Detailed Site Plan

Salubria Center

DSP-23015

STAFF REPORT

Figure 1: Detailed Site Plan

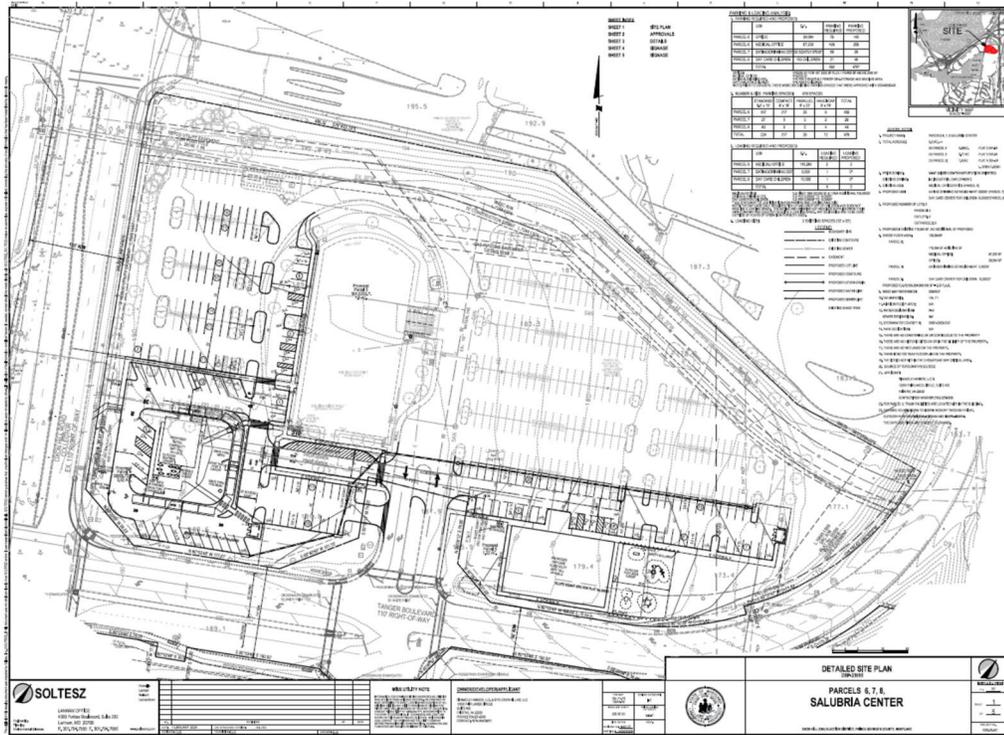
1. Prior to certification, the detailed site plan shall be revised, or additional information shall be provided, as follows:
 - a. Show dimensions for all sides of the proposed buildings, including the entry vestibule.
 - b. Show the setbacks from the street to the day care building.
 - c. Show day care center play area gate locations on all site plans.

- d. Show the setback from the street of the proposed freestanding sign planned for the day care center.
 - e. Provide full proposed canopy details for the proposed removal and replacement of the existing porte cochere at the entrance of the existing office building.

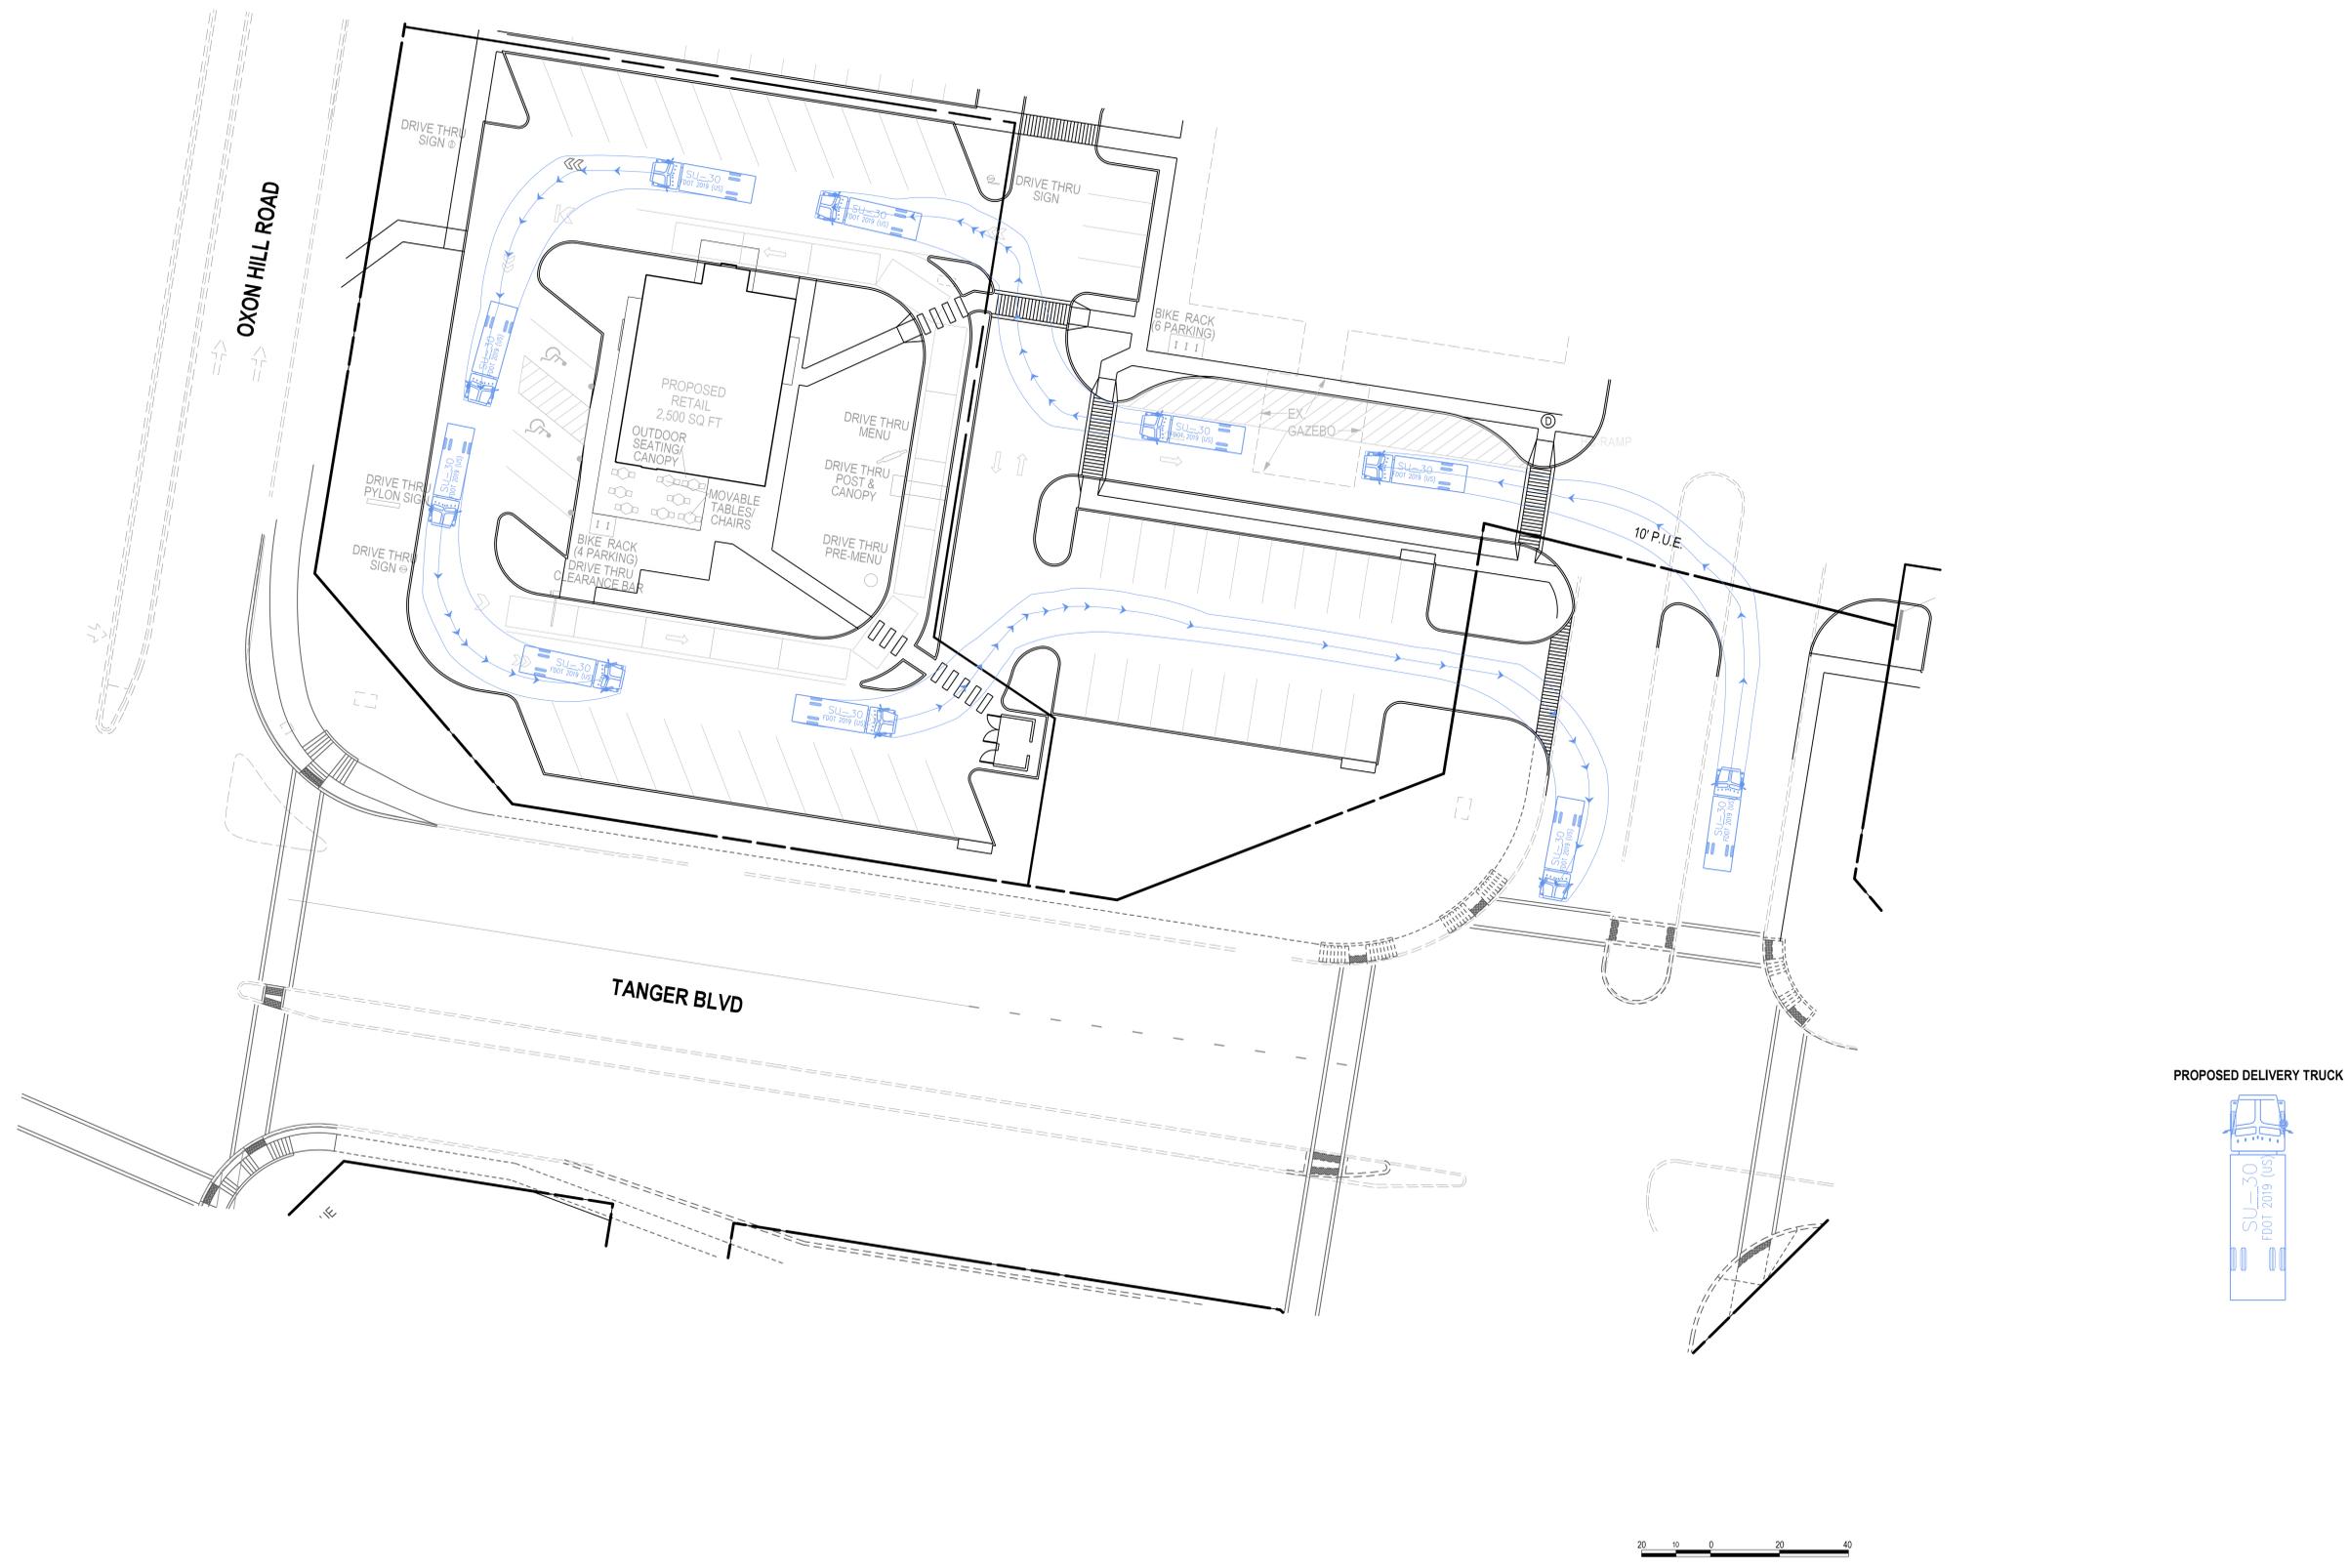
Comment 2: Please provide the location of any proposed fire department connections (FDC's.) A hydrant must be provided within 200' of all FDC's measured as hose is laid by the fire department in accordance with Prince George's County Subtitle 4-167.

Response: **The FDC's are for the new buildings are not finalized yet. The daycare FDC will most likely be located on the front of the building. And the Eating and Drinking Establishment FDC will most likely be located on the south or west side of the building. At the time of permit, the FDC's will be within 200ft of all hydrants.**
